118 MERCER

SDCI #3036517-LU (3036455-EG)

DESIGN REVIEW BOARD RECOMMENDATIONS

08/04/21

EDG RESPONSES - 1A PREFERRED MASSING

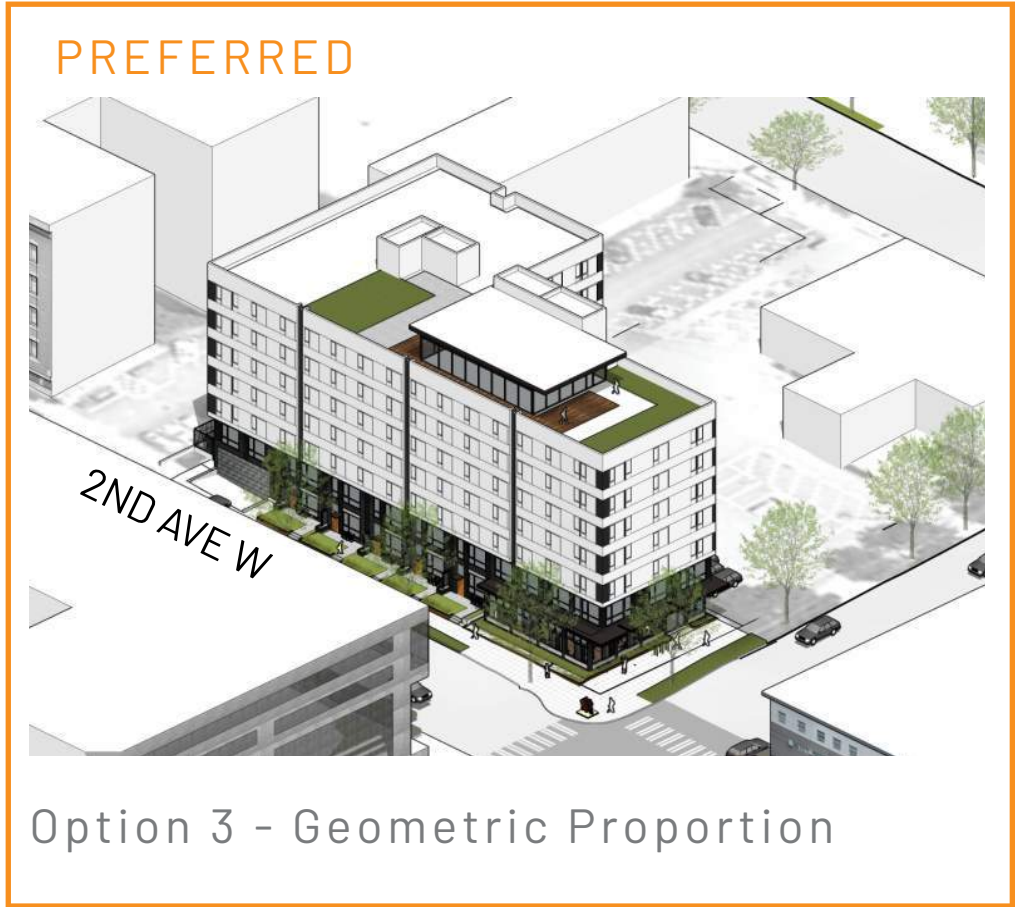
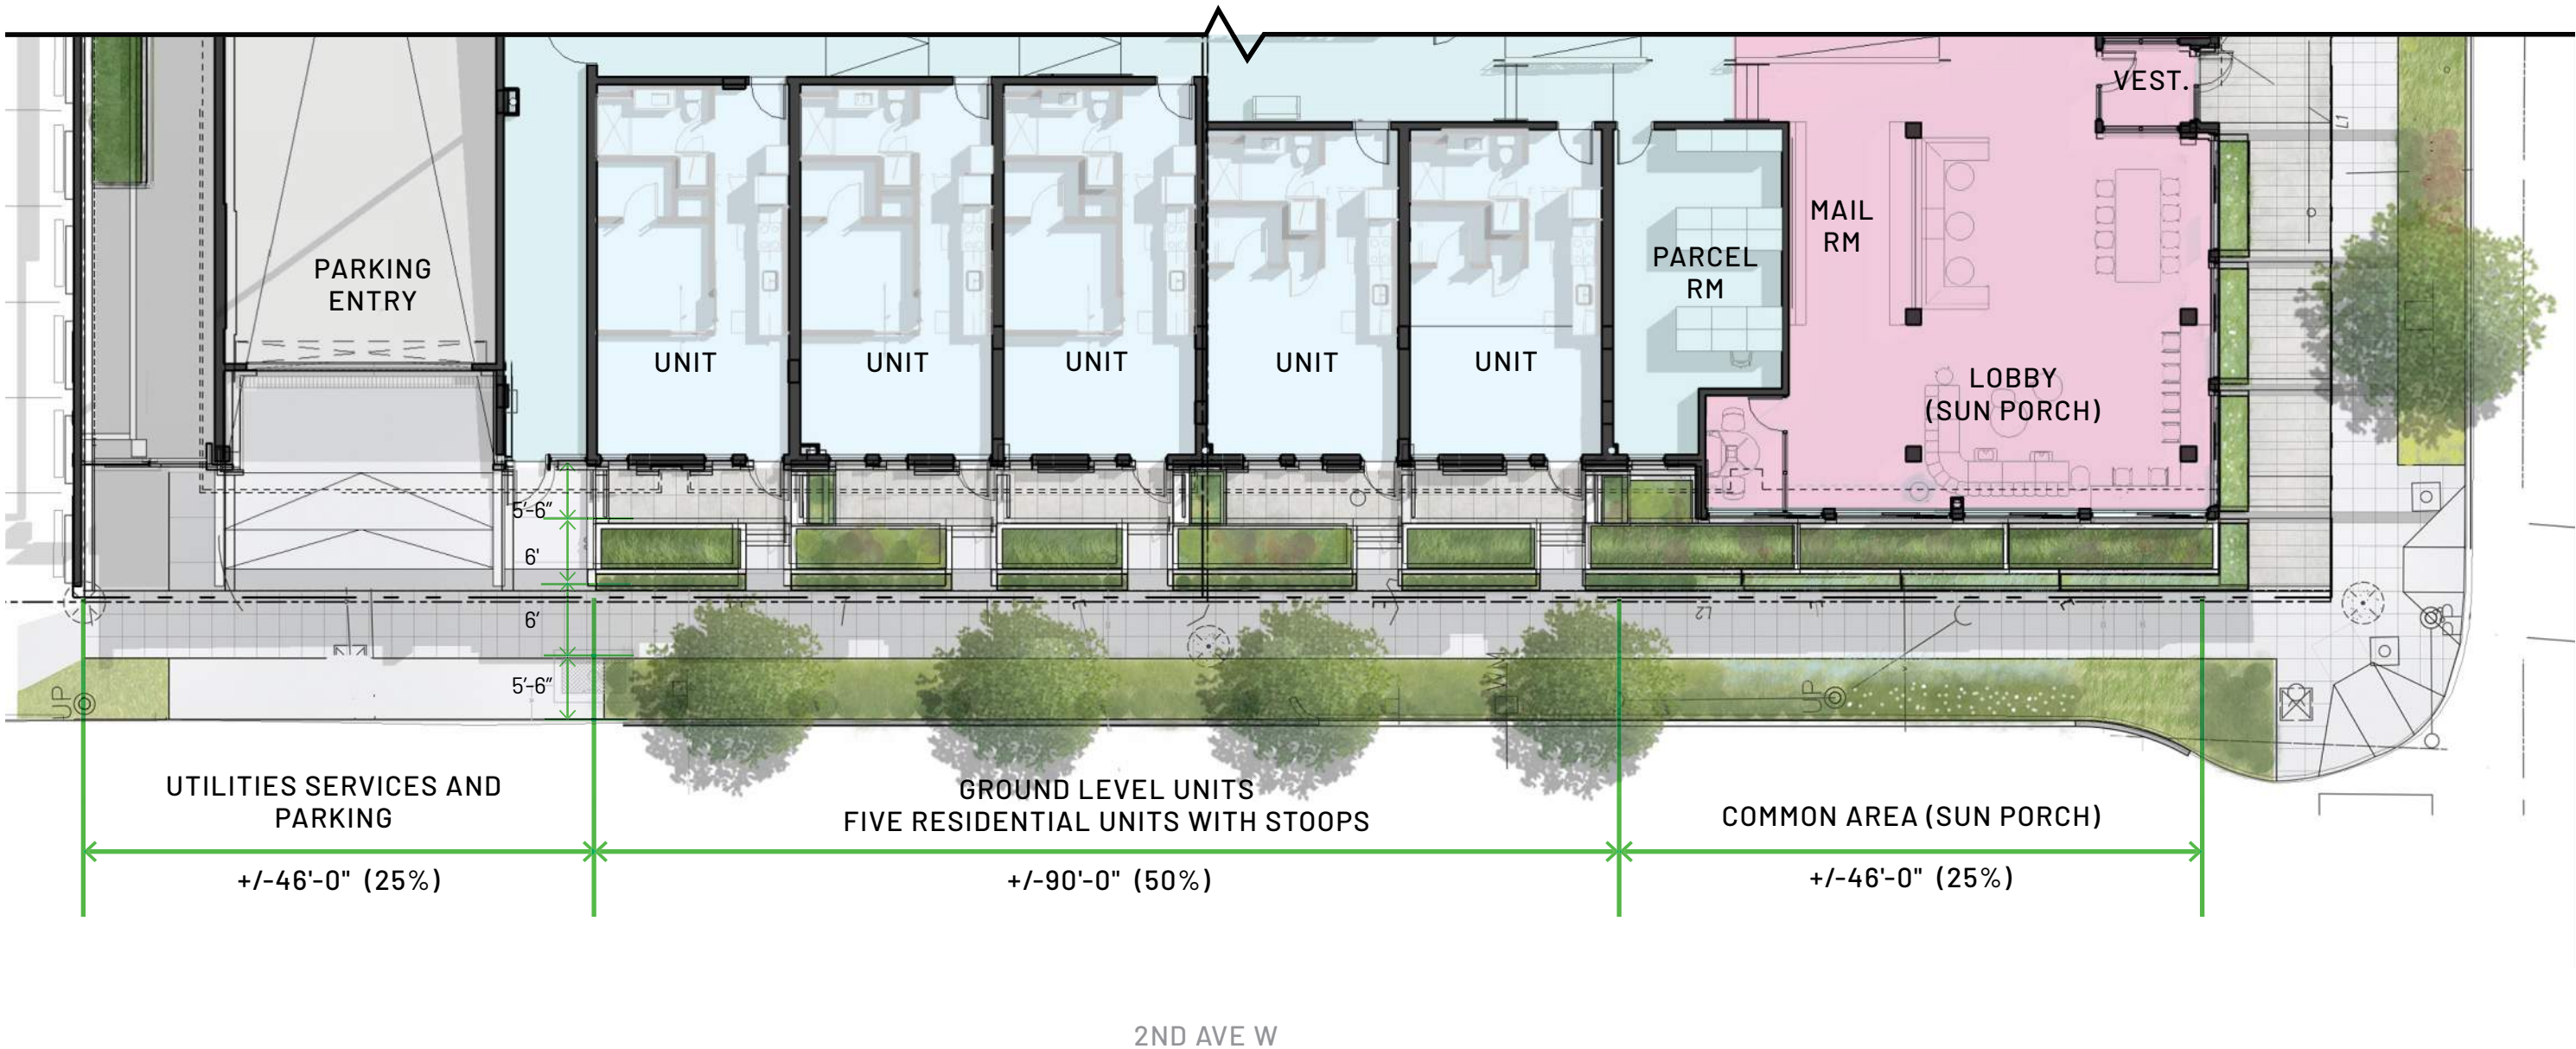
The board **preferred Option 3** over the other two massing options due to its taller two-story base height compared to the other options and **its incorporation of regular façade reveals on the street-facing upper-facades.** (CS2.A, DC2.1.A)

The design continues developing option 3. Option 3 is defined by its two-story base, standalone penthouse (sky lounge), and gaskets. Compared to the other massing studies, the preferred massing option 3 provides an **appropriate scale and proportion.**

The design was inspired by a geological interpretation of the site. The site is isolated and surrounded by surface parking and flat surface buildings. The project takes abstract inspirations of the eroding vertical features and applies them to the building design. The **setback of the sky lounge** significantly mitigates the overall building height, mass, and scale. The **gaskets create a design rigor** with repeating horizontal bays. The dimension of the small street facade along W. Mercer determined the interval distance between the gaskets.

EDG RESPONSES - 1B ARCHITECTURAL PROMIENCE

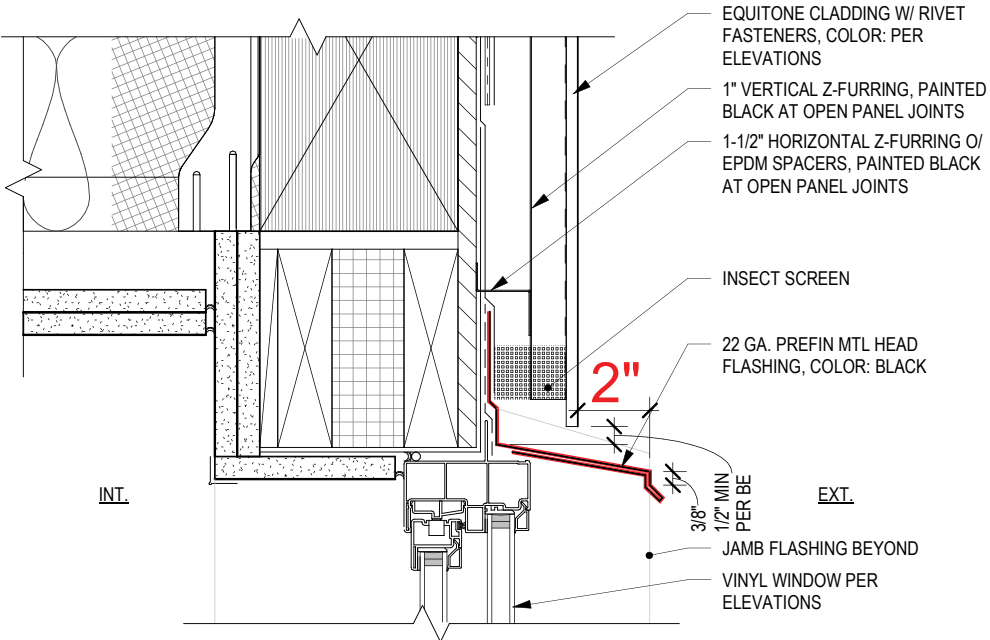
1b Strengthen the southern massing expression. "Add architectural prominence."

The Board identified the need to strengthen the massing expression of the southern portion of the Option 3 building design near the street intersection. The taller massing of Option 2 was cited by the Board as a possible solution that would add architectural prominence at the street corner and better relate to contextual building heights. The Board specified that adding prominence through height should express the southern massing without being imposing to surrounding development (CS2.A, CS2.D.3, DC2.C.3)

Per recommendation, the design team completed a handful of massing studies to explore techniques which add prominence to the southern massing.

Adding mass to the southern volume created an imposing condition at the corner upon the intersection and pedestrian environment (Study 5). Adding a top element at the corner unduly weakened the design parti (Study 6). Different methods of articulating the corner through erosion were explored within the more appropriate 7-story corner volume (Study 2/3/4), however none of these studies yielded a more striking upper volume than that which had been previously provided.

As shown on this page, the design is best served by the increased prominence of the **sun porch element** and it's **connection to the ground floor plaza** which **reinforces the scale of the pedestrian** realm. The contrast of the highly articulated "jewel-box" and the clean rigor of a consistent 5-story upper volumes appropriately celebrates the corner, while upper art panels both soften and highlight the facade transitions.

EDG RESPONSES - 1C SECONDARY ARCHITECTURAL FEATURES

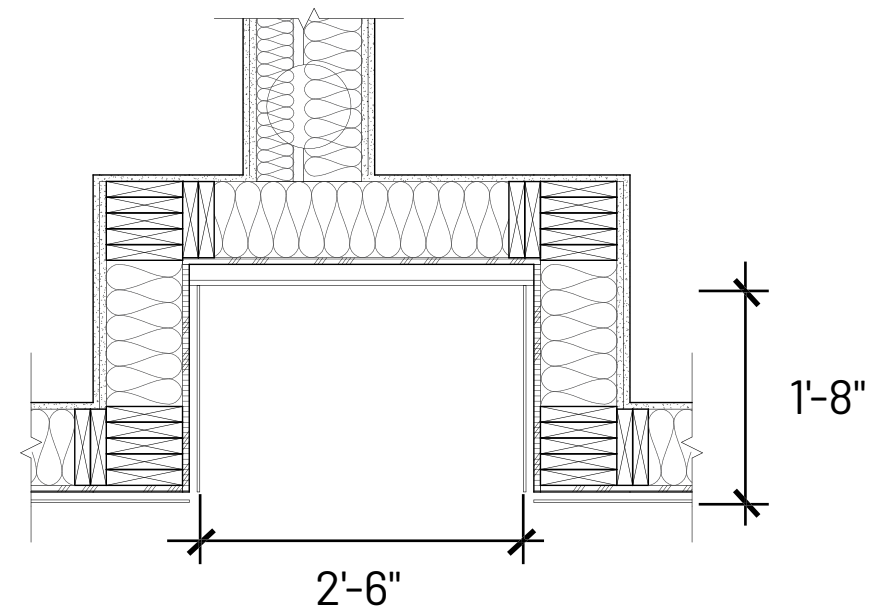
1c Break-up the upper façade at 2nd Ave W. "Include larger massing moves & secondary architectural features."

The board emphasized the need to break-up the relatively long upper-façade along 2nd Avenue W. of Option 3 using both larger massing moves, such as increased width and depth of façade reveals, and secondary architectural features. The board specifically identified the vertical gaskets along the east building façade as sufficiently-sized massing elements that could be implemented on the west façade. (DC2.A.1, DC2.A.2, DC2.C)

Gasket depth along 2nd Ave W have been increased **by 20%** (from 1'-8" to 2'-0") and widened by **33%** (from 2'-0" to 2'-8") with an additional gasket added along the north facade. Per recommendation, the design team completed a handful of massing studies to explore techniques that incorporated larger massing moves into the upper façade, including using similar size gaskets to those on the east facade. We were therefore able to observe that wider gaskets (Study 3) in fact weaken the strength of the upper form, while deeper gaskets (Study 5) weaken the contrast between the two-story base and five-story upper façade.

Additional studies of façade proportion (Study 4) and accent materials (Study 2) were undertaken in order to test other techniques, however within the context of the design concept these moves became arbitrary,

EDG RESPONSES - 1D TWO STORY BASE

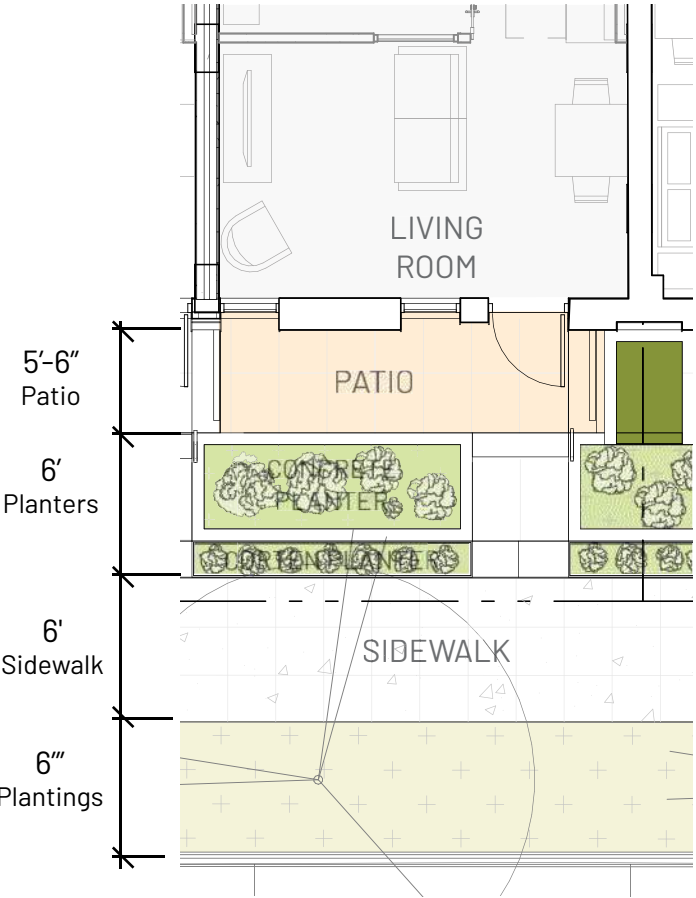
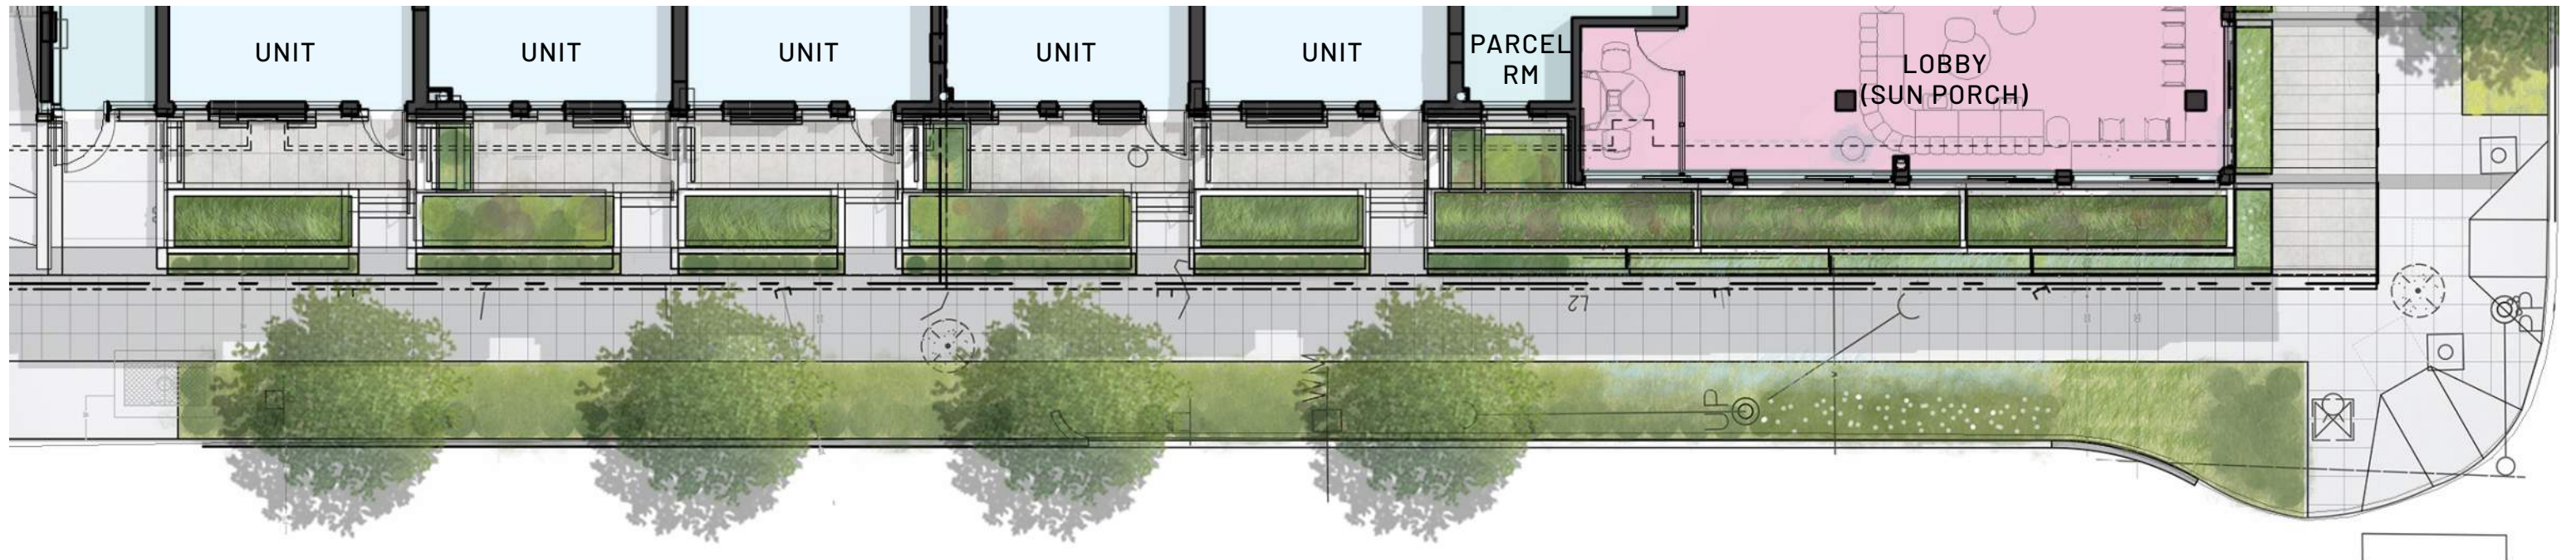
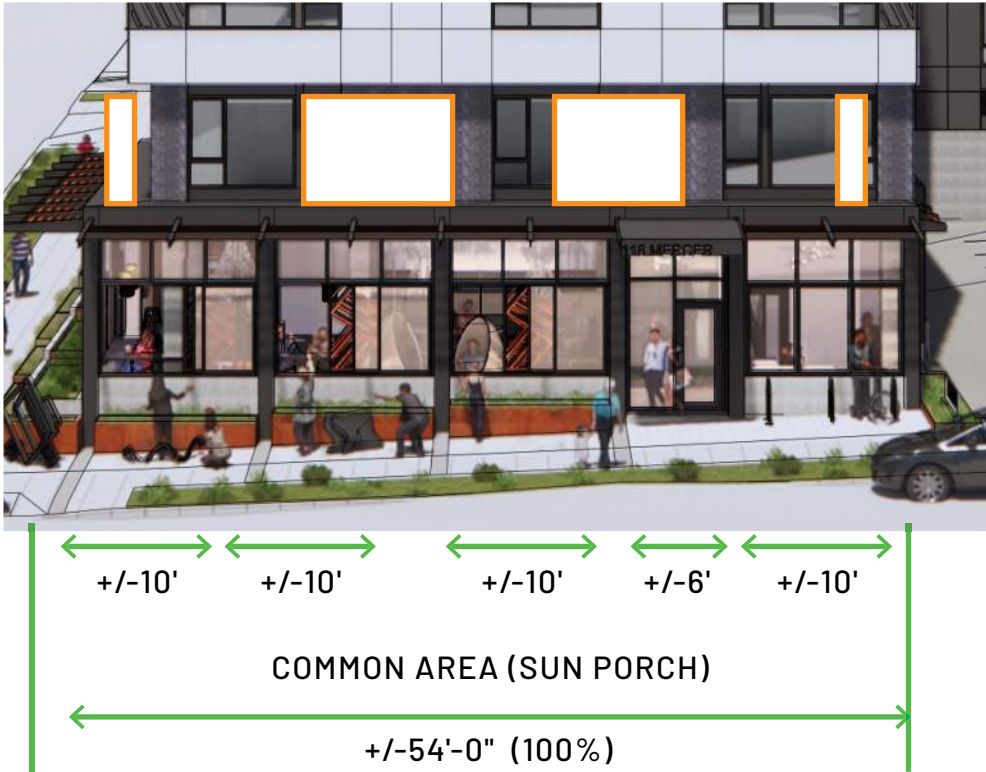
1d Provide additional modulation of the two-story base façade at 2nd Ave W. "Provide more sufficient visual segmentation."

The board supported the conceptual two-story base height of Option 3 and added that the changes in exterior materials would not be sufficient for segmenting the visual length of the façade along 2nd Avenue W. The board promoted strategies such as extending massing moves from the upper-façade to the base and adding secondary architectural features such as columns and canopies in the base to achieve sufficient visual segmentation of the façade. (CS2.C.1, DC2.A.1, DC2.A.2, DC2.C, DC4.1)

Through refinement of the design concept as depicted on this page, the design team has shown that finely articulated materials and subtle facade depths provide visual segmentation for a building of this scale.

Textured cladding in the gaskets **tie together** the **upper mass** and the **two-story base**. Material depth and edge detailing is an appropriate secondary architectural feature at this fine-grain scale, and augmented by refined stoop elements such as art screen dividers, integrated seating, tiered planters and horizontal canopies.
